FINDING OF NO SIGNIFICANT IMPACT

INTERSTATE 70/KIPLING STREET INTERCHANGE

Project Number: C0703-406, Project Code: 19761

Finding of No Significant Impact (FONSI)

Figure 2 Proposed Action Alternative

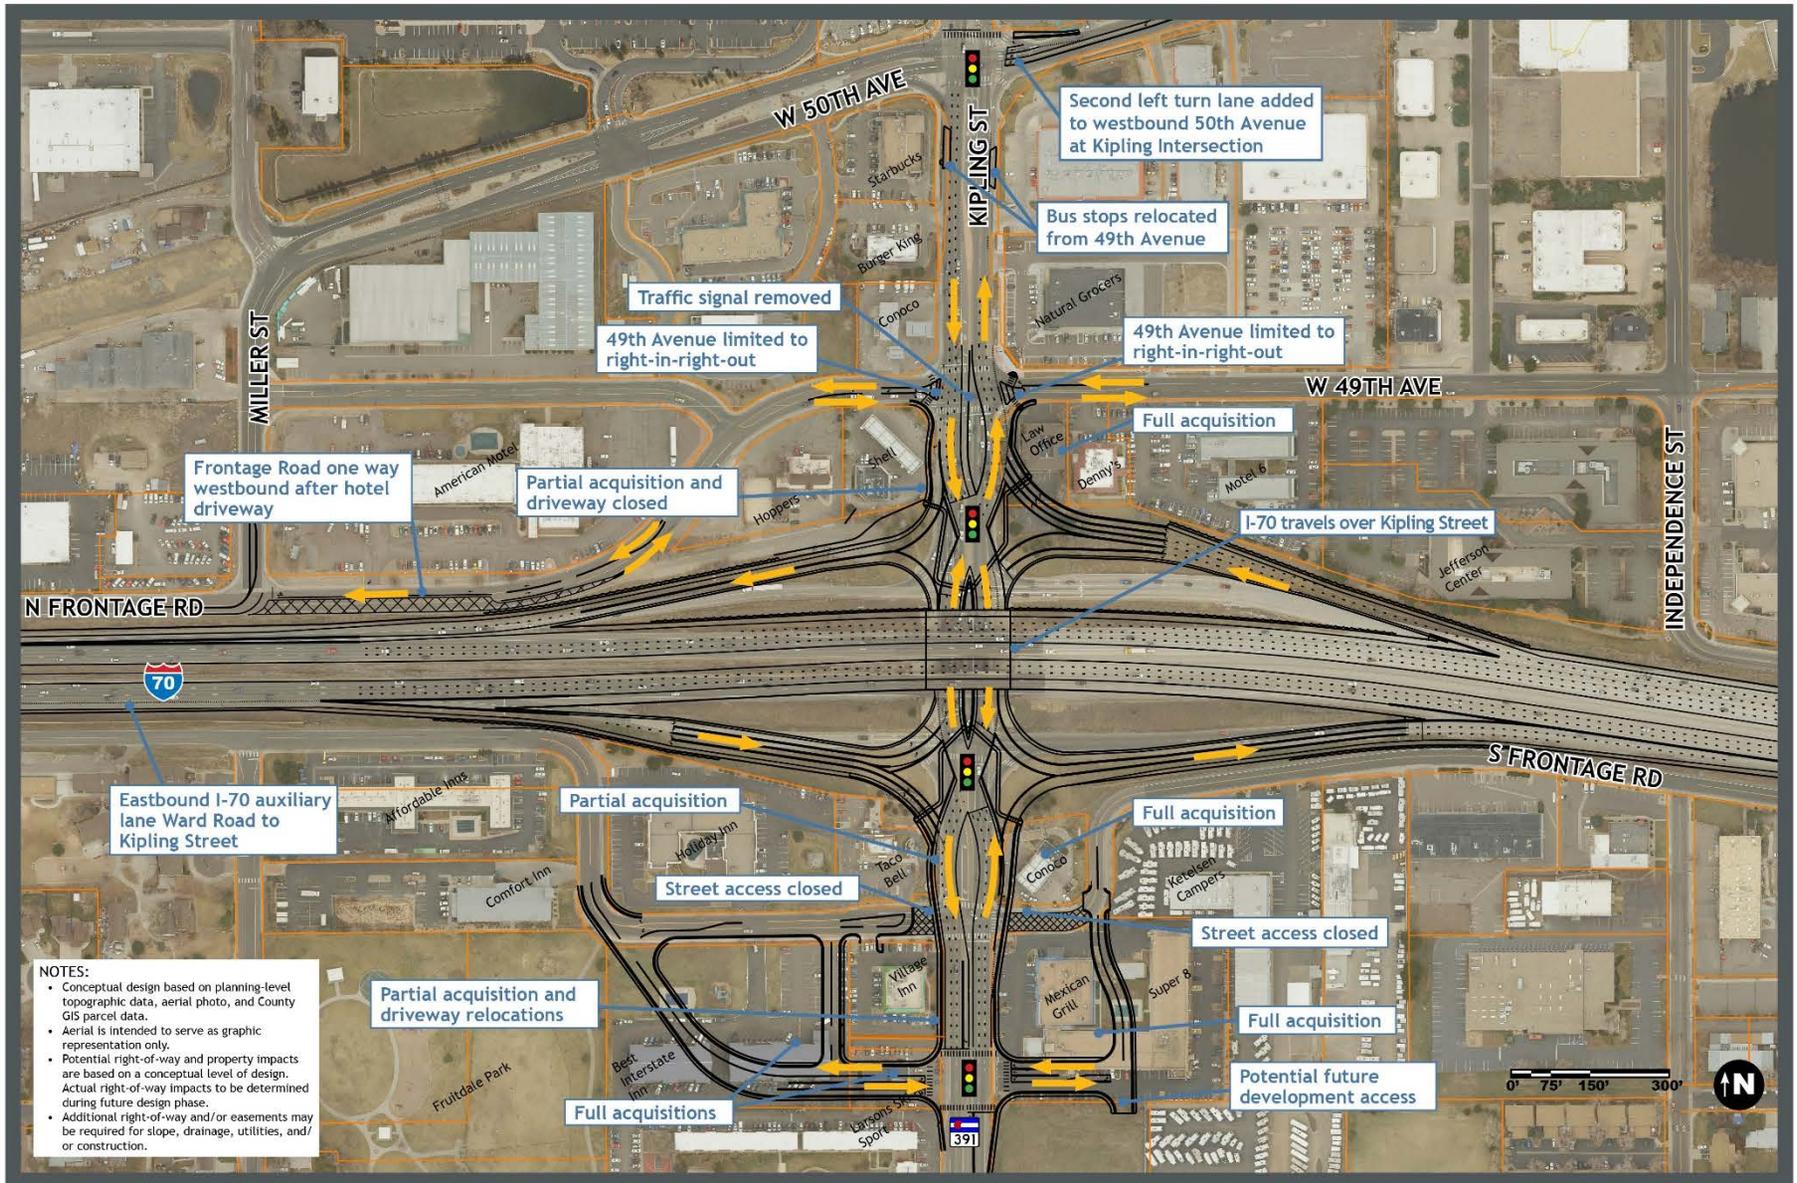
A We understand the need for the traffic flow improvement. Kipling is a nightmare. While looking at the flow of traffic on/off the highway, please DO NOT FORGET Kipling traffic volume both north + south of I-70. If you put the DDI in place + ignore the rest of Kipling, the bottle neck will build up as soon as you pass through the DDI, because it's too narrow. Also, we understand some properties need to be acquired, however, it is vitally important to help long standing business in Wheat Ridge (Larson's Ski Sport) find + set up shop in Wheat Ridge prior to the Kipling location closure.

B This SHOULD NOT drive them out business or out of Wheat Ridge! They are a major support in our city + have have been for years. Change is needed but please don't touch those businesses that are vital to our city. Also, discuss access issues with Natural Grocers. We've worked a long time for them + love their business.

C (see reverse side) Thank you!

A – The operational analyses completed for the study included the traffic volumes and movements along Kipling Street from 44th Avenue to 50th Avenue. Additional lanes on Kipling Street are included in the design at and between the South Frontage Road and 49th Avenue intersections.

The traffic operational analyses and design at the I-70/Kipling interchange considered a separate planned and funded project to widen Kipling Street from four lanes to six lanes From Colfax Avenue to I-70. That project is in the DRCOG 2040 Metro Vision Regional Transportation Plan (DRCOG, 2018) for the 2030 – 2040 planning years.

B – Potential business relocations have been communicated to affected property and business owners during the development of the conceptual design and EA. Property acquisitions will conform to requirements set forth in the Uniform Relocation Assistance and Real Property Acquisitions Policies Act of 1970 (Public Law 91-646 as amended). CDOT cannot dictate where a business chooses to relocate to, or whether the business owners choose not to reopen elsewhere.

C – Please see response to comment #12A regarding the Natural Grocers access.
